Planning Committee

Item No: 8.1	Classification: Open	Date: 05 March 2019	Meeting Name: Planning Committee
Report title:		Addendum report Late observations and further information	
Ward(s) or groups affected:		Old Kent Road	
From:		Director of Planning

Item 8.1 – Application 18/AP/3246 for: Full Planning Application – Land at Cantium Retail Park, 520 Old Kent Road, London SE1 5BA

B&Q Indicative plan

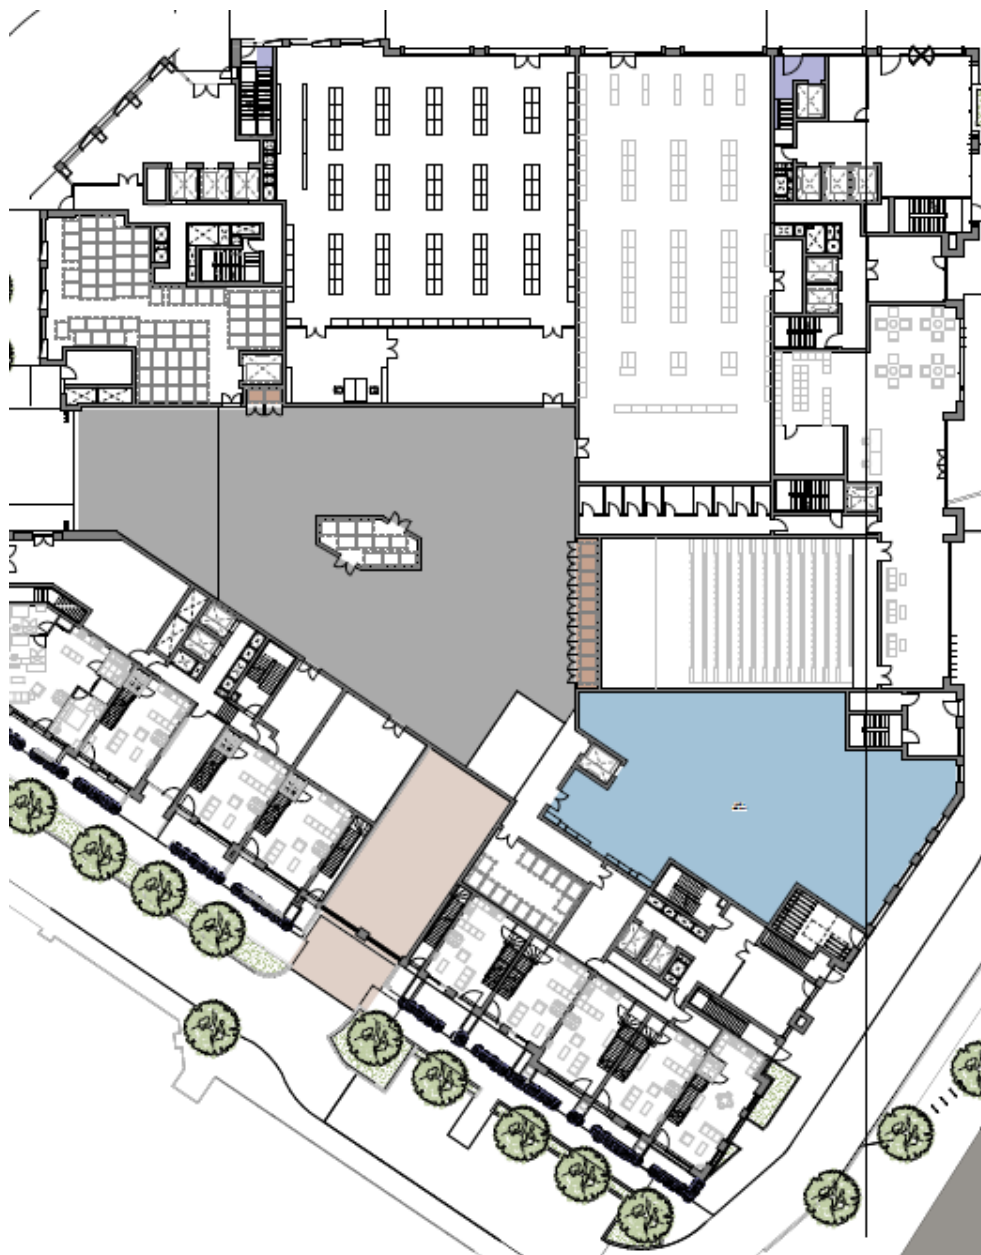
Issue	Response
B&Q re-provision	<p>As per the main report, B&Q would be offered first refusal on the destination space, at normal market rates. In addition, the applicant has prepared a plan to show how B&Q could fit into the destination space, which will be included in the officer presentation. The plan makes provision for 437sqm of potential space for B&Q.</p> <p>Officers would secure advice and undertake benchmarking on the rents to ensure the market rate would be fair and would reflect a brand new, retail facility.</p>
Destination space – deletion of offices from the flexible uses sought	<p>Paragraphs 20 & 118 of the main report refer to the inclusion of offices as one of the flexible uses for the destination space. Following some additional negotiations with the applicant, they have agreed to limit the uses proposed for the destination space to Class A, Class D and Sui generis (theatre) use classes only. A new condition has been included which can substitute condition 42 and can be found below.</p> <p>“Notwithstanding the provisions of the Town and Country Planning (Use Classes) Order and any associated provisions of the Town and Country Planning General Permitted Development Order (including any future amendment or enactment of those Orders), the destination space use hereby permitted shall include use</p>

Block B design changes

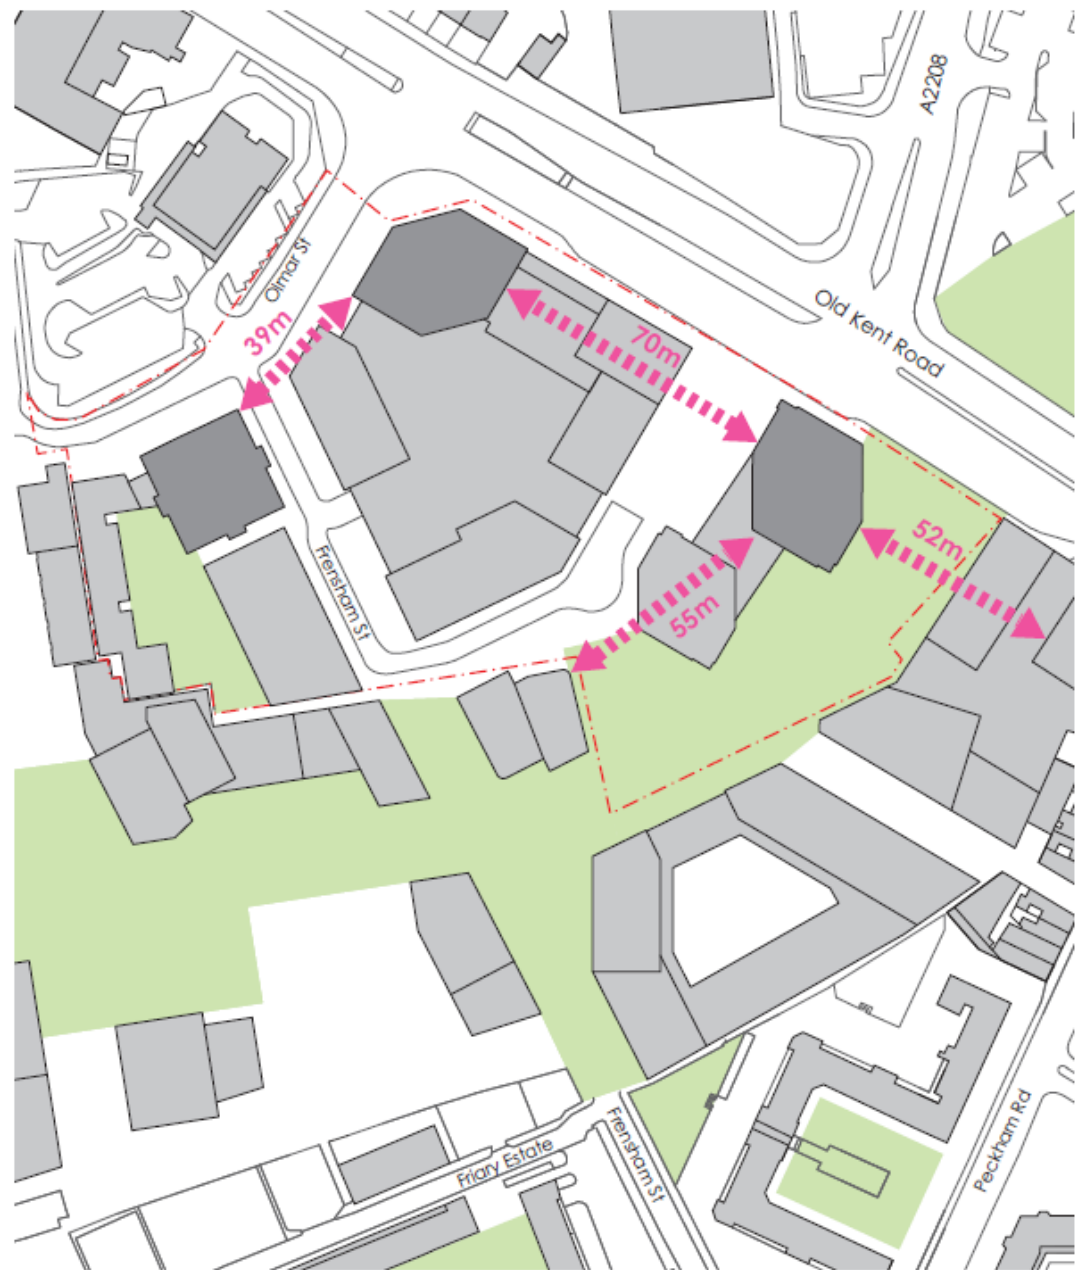
Block B showing the slot between B.III and B.IV prior to widening shown from the south west.

Block C, Forty-Sixth Floor Plan

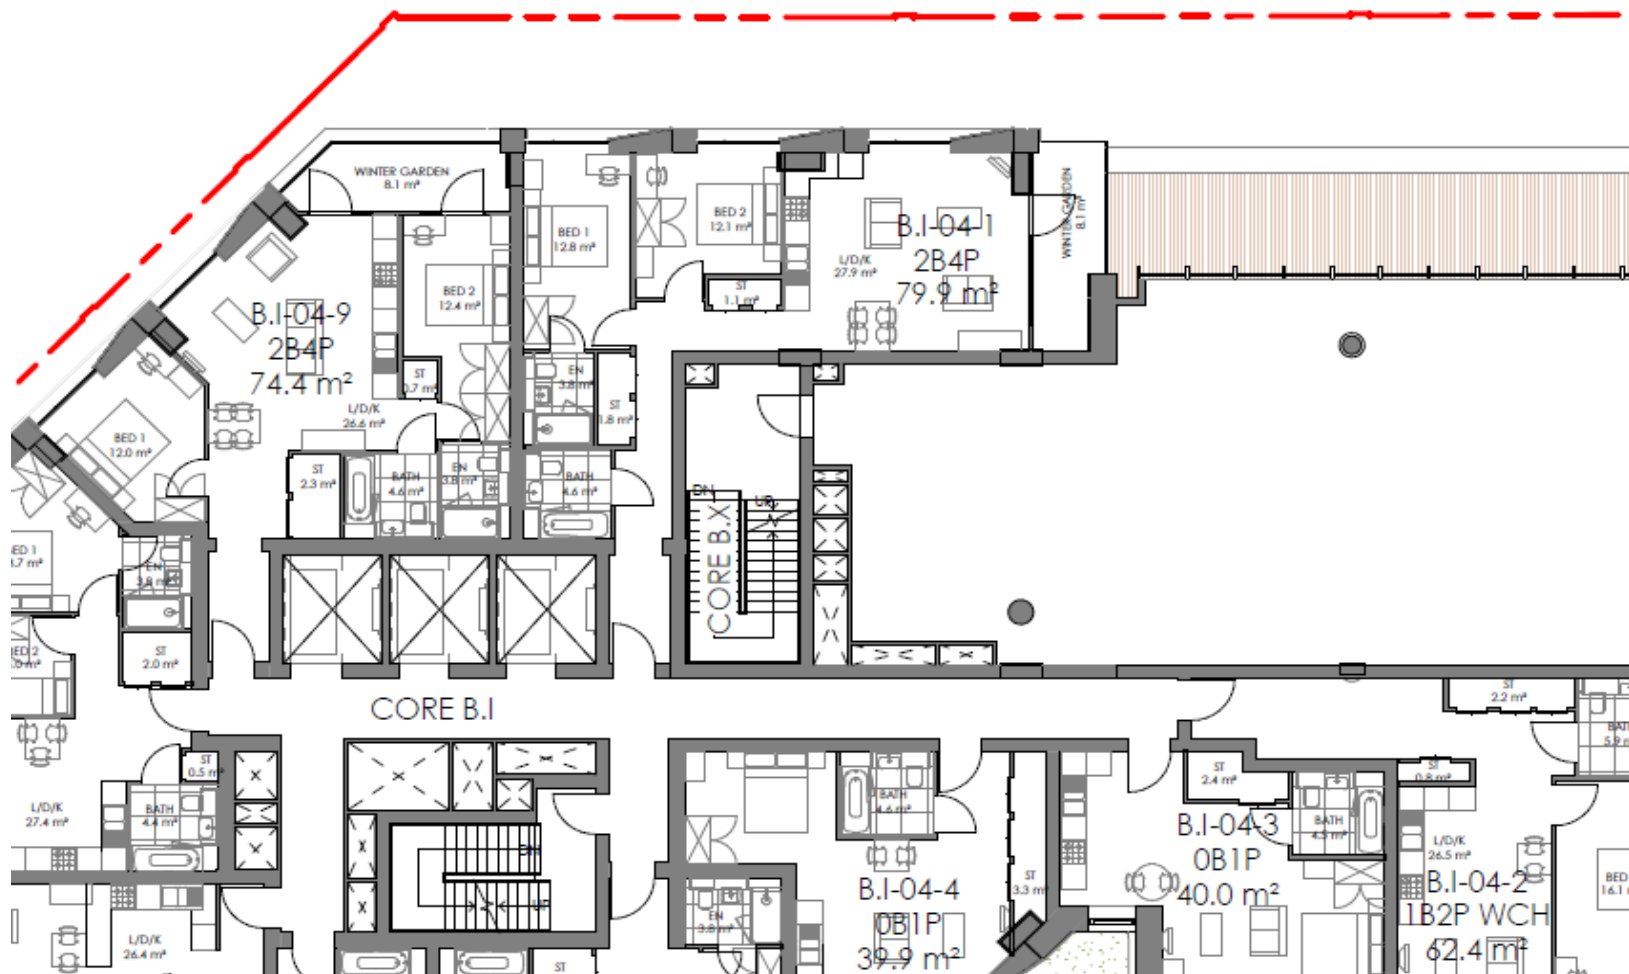
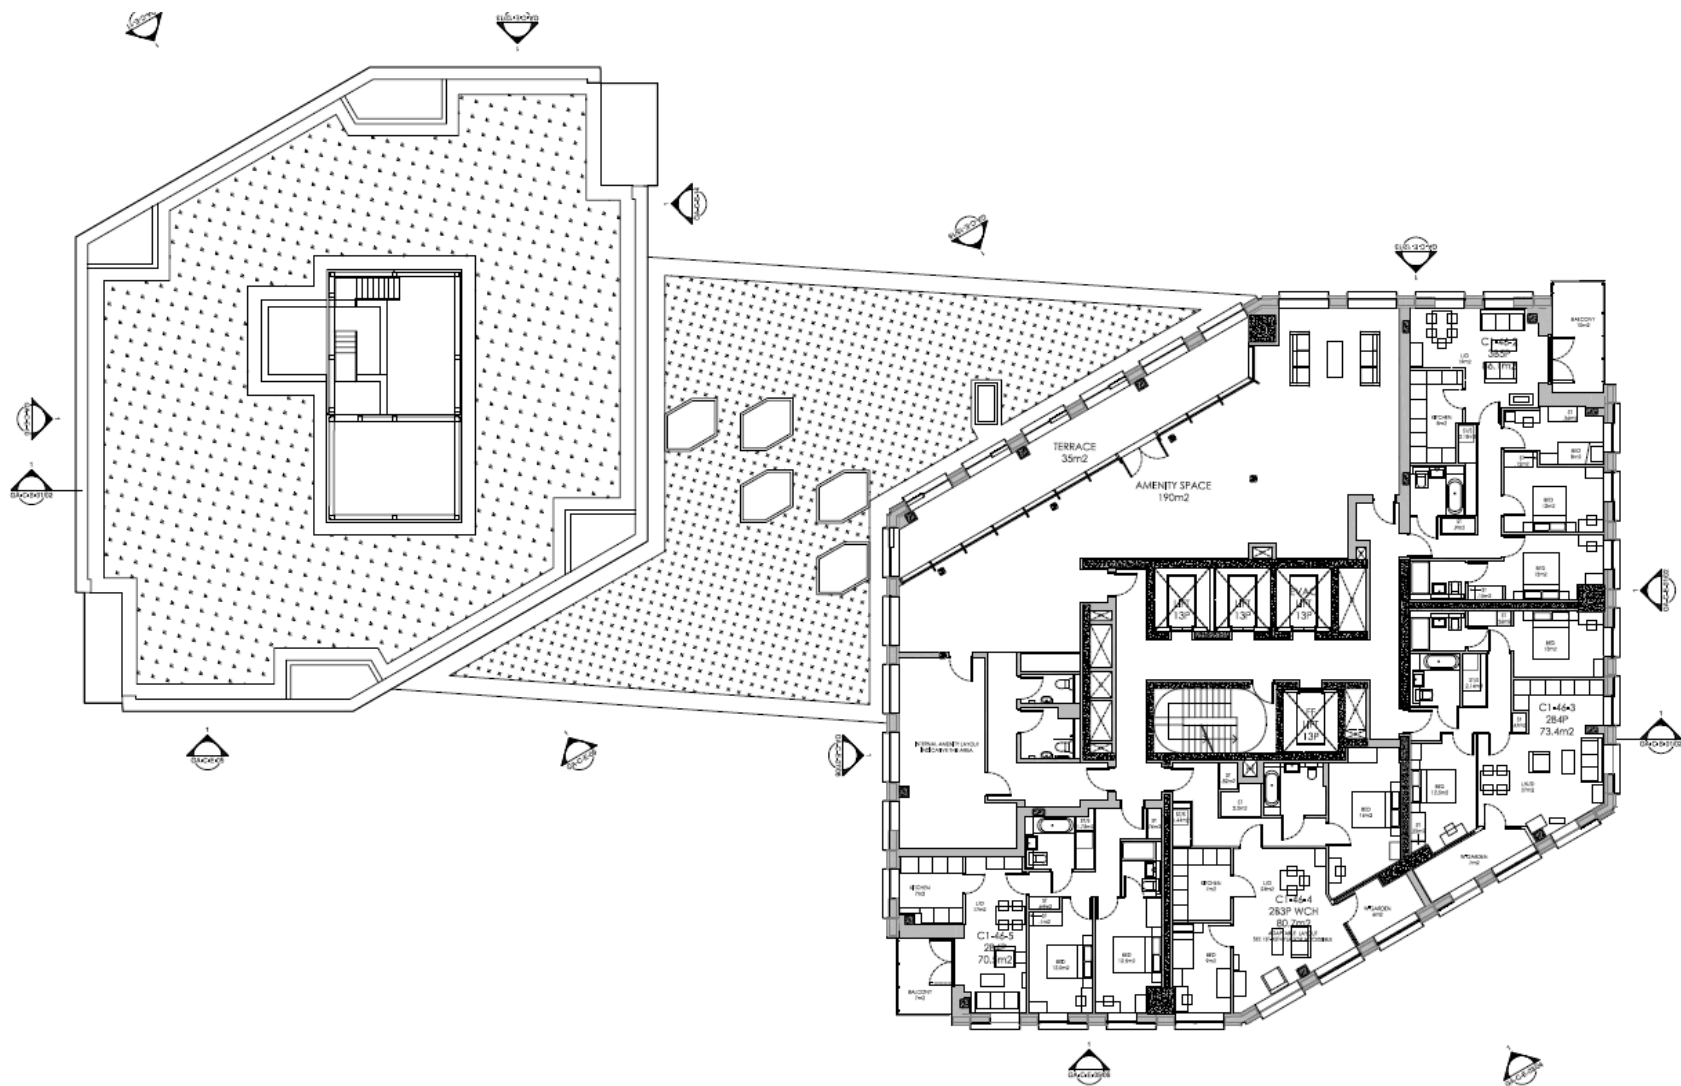
Public access on Tower C	Paragraph 661 refers to the public access that would be secured to the 46 th floor of the Block C tower. The applicant has provided some additional details of how the access would work. Access would be provided to local stakeholder groups for up to 12 days per calendar year. There would be no charge for the use of the space for these groups. It is proposed that the type of groups that can apply to use the facility and the process for booking and access can be agreed as part of the Site Management Strategy (to be submitted and agreed prior to first occupation).
---------------------------------	---

would be offered for 25 years, which is considered reasonable.
Independent retail provision	Paragraph 99 of the main report refers to the independent retail provision that would be secured in Block C. The applicant has advised that they would market the units for one year after which if no independent tenant was found then the provision would no longer apply. This is considered a reasonable period of marketing.
Site Management Strategy	Details of this strategy can include the free access offered to the 46 th floor of Tower C.
